# **Intel® Desktop Board D875PBZ Specification Update**

Release Date: August 2004

Order Number: C40099-010

**Figure 26a. Omnidirectional Airflow Heatsink**

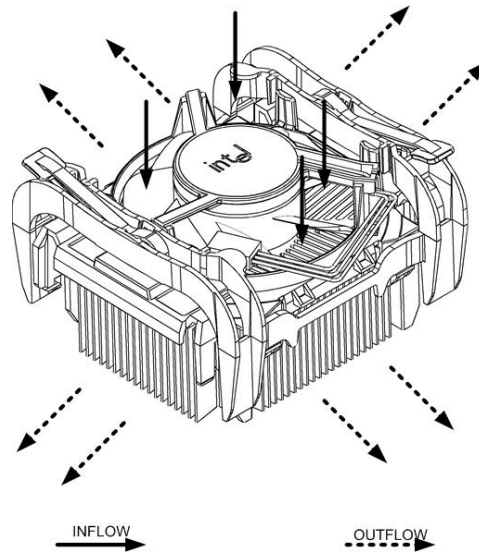
#### 4. **Change to Thermal Considerations, Section 2.12**

Section 2.12, Thermal Considerations will change in its entirety as follows:

*The use of an Intel Pentium 4 processor with 1 MB of L2 cache on this Intel desktop board requires the following:*

- *A chassis with a maximum internal ambient temperature of 38 Degrees Celsius*
- *A processor heatsink that provides omnidirectional airflow so that air is drawn across the processor voltage regulator area (item A in Figure 27). Figure 26a illustrates an omnidirectional airflow heatsink.*

**Figure 27. Localized High Temperature Zones**

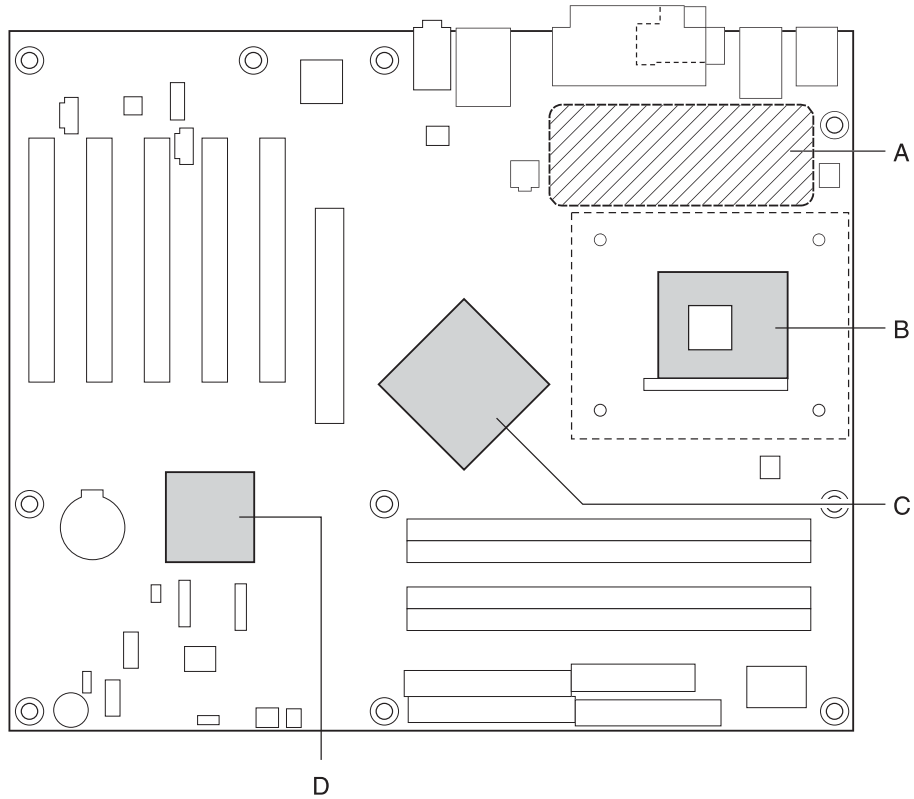
Ensure that proper airflow is maintained in the processor voltage regulator circuit. Failure to do so may result in damage to the voltage regulator circuit. The processor voltage regulator area (item A in Figure 27) can reach a temperature of up to 85 °C in an open chassis.

Figure 27 shows the locations of the localized high temperature zones.
